# Campaign Service

**BULLETIN NUMBER:**  
CB22-J-002

### IMPORTANT SAFETY RECALL

### ENGINE EXHAUST BRAKE REPROGRAMMING – 22V-508

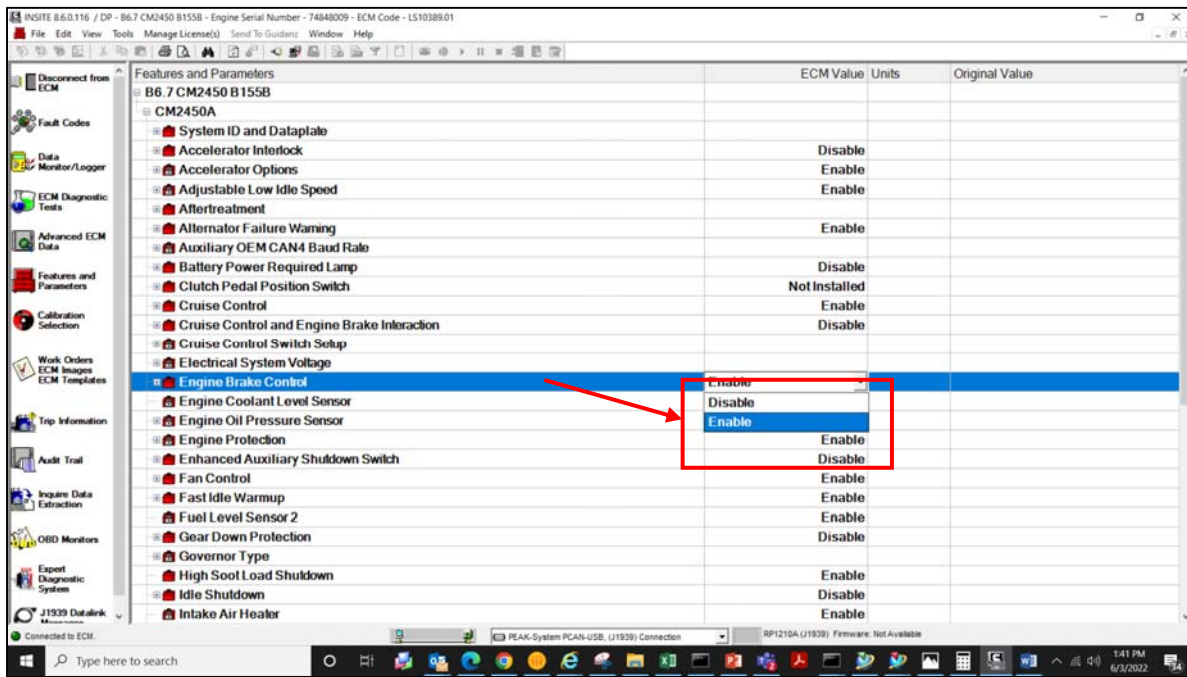
6. Select **Engine Brake Control** and confirm it is “Enabled”.

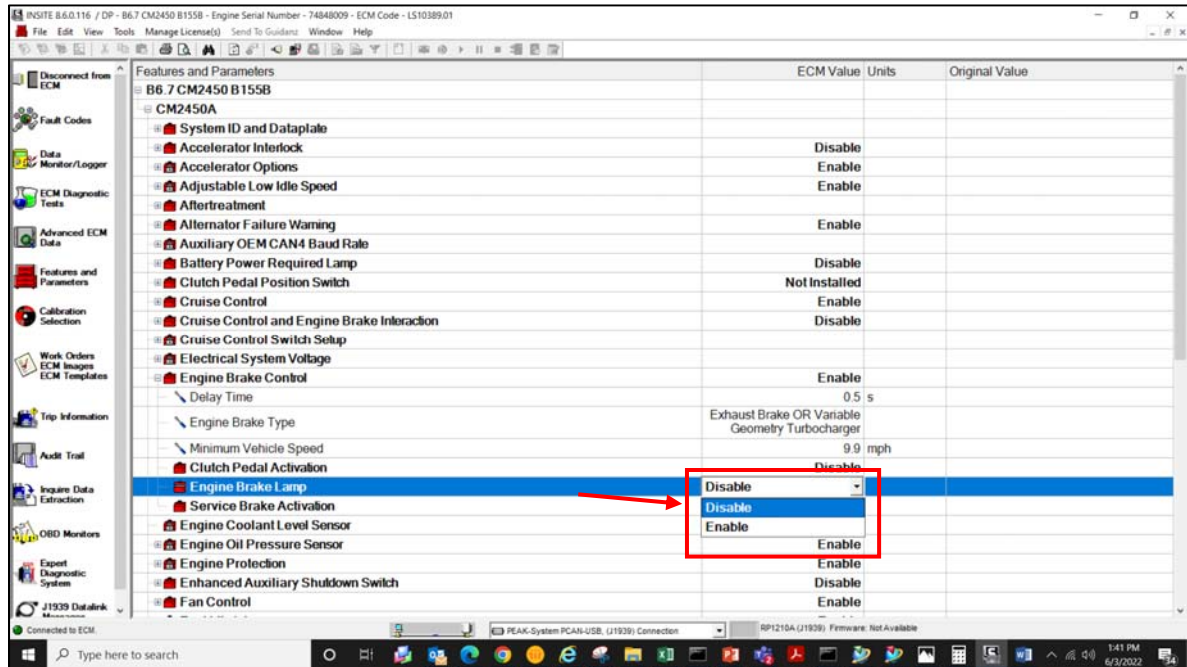
7. If it is not Enabled, select **Enable** for Engine Brake Control at the drop-down menu.

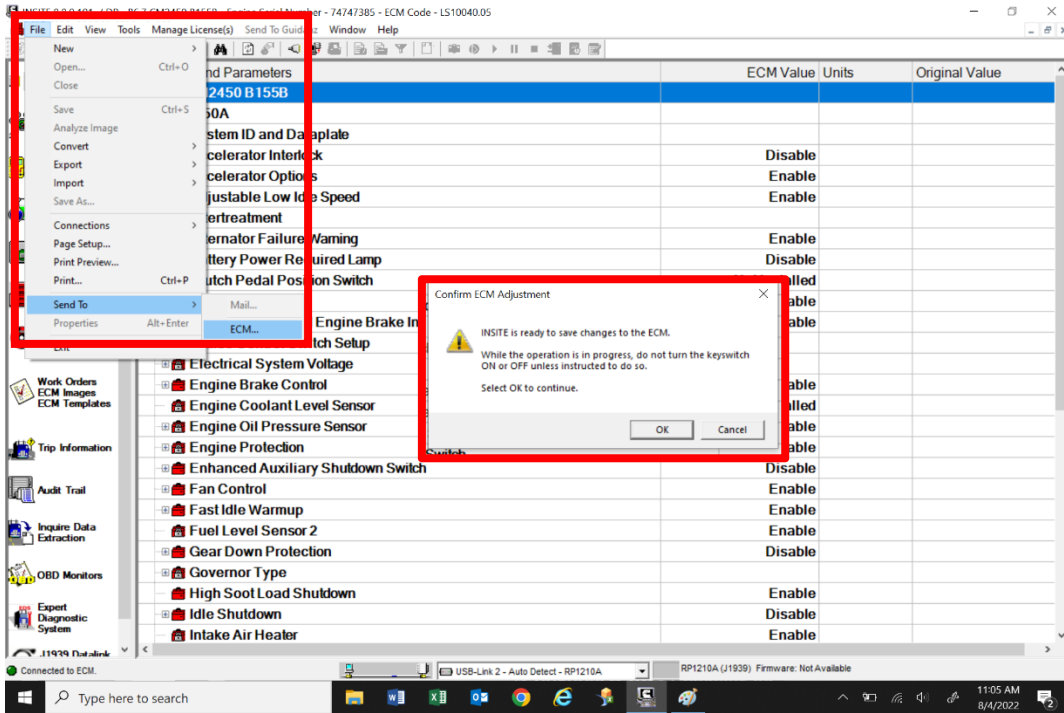
8. Expand “ENGINE BRAKE CONTROL” by selecting the “+” and ensure “ENGINE BRAKE LAMP” is **DISABLED**.
